City Planning Commission  
Sacramento, California

SUBJECT: Special Permit to develop 74 halfplex units in proposed R-1A zone (P83-215)

LOCATION: West of Windbridge Drive and Flowerwood Way, east and south of drainage canal and Durfee Way

\*\* AMENDED STAFF REPORT 7/28/83  
**CITY PLANNING COMMISSION**

EXHIBIT A-3

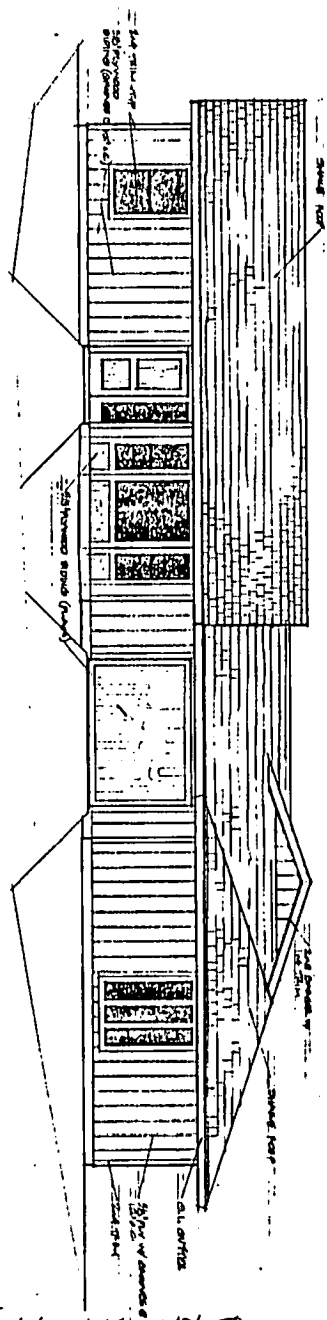
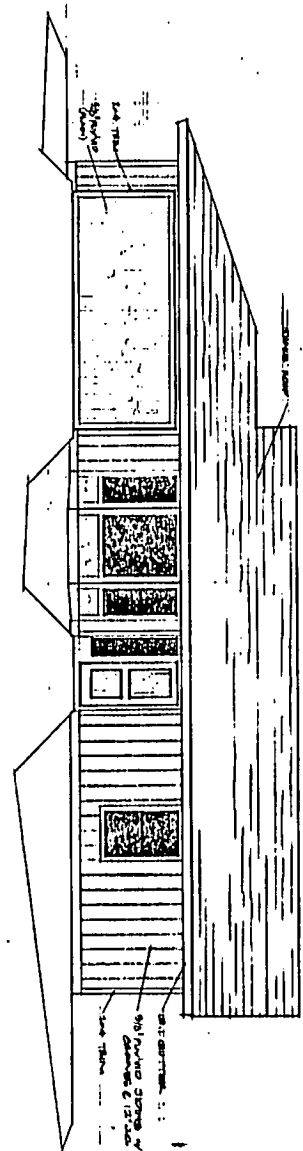
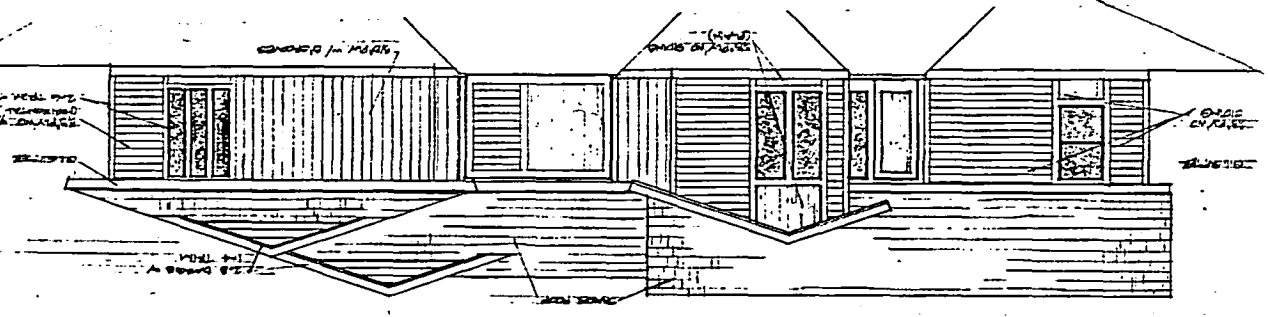
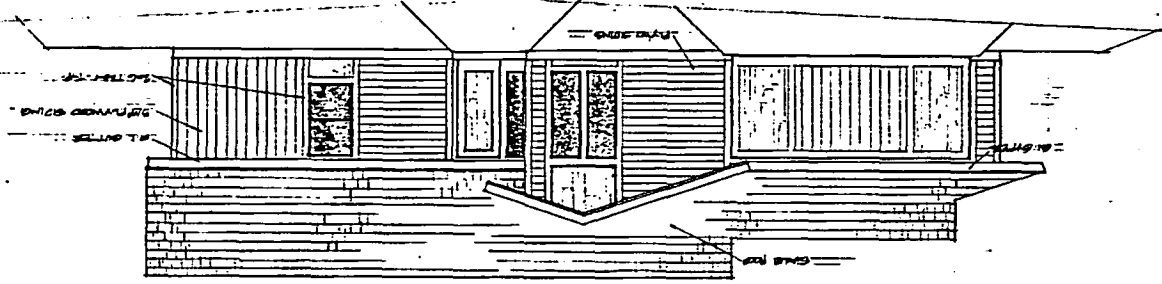
The additional floor plan and elevations are an improvement; however, staff believes that one additional floor plan is necessary in order to provide a greater variety in design for the overall subdivision. A variety is especially needed in areas where there is a cluster of halfplex units. Three floor plans would avoid duplication of structures that are basically the same in size and bulk.

5. The applicant is proposing a single floor plan and elevation for all 37 structures (74 units). Staff has a concern with the use of only one plan because there will be a lack of variety for the neighborhood. In some cases there will be groups or clusters of corner lots with the same structure. Staff believes that a minimum of three-four different elevations and floor plans should be utilized to allow a greater variety. Also, a variety of roof styles and building material should be incorporated into the design.
6. Traffic Engineering has expressed concern about the driveways being too close to the corner radius which causes visibility problems. Staff suggests that the units with the driveway too close to the intersection be redesigned to resolve this problem.

1. *An additional elevation and floor plan (3 total)* shall be submitted by the applicant for staff review and approval prior to recordation of the final map; *(amended by CPC)*
2. Driveways shall be located away from the corner radius to the satisfaction of the Traffic Engineer.
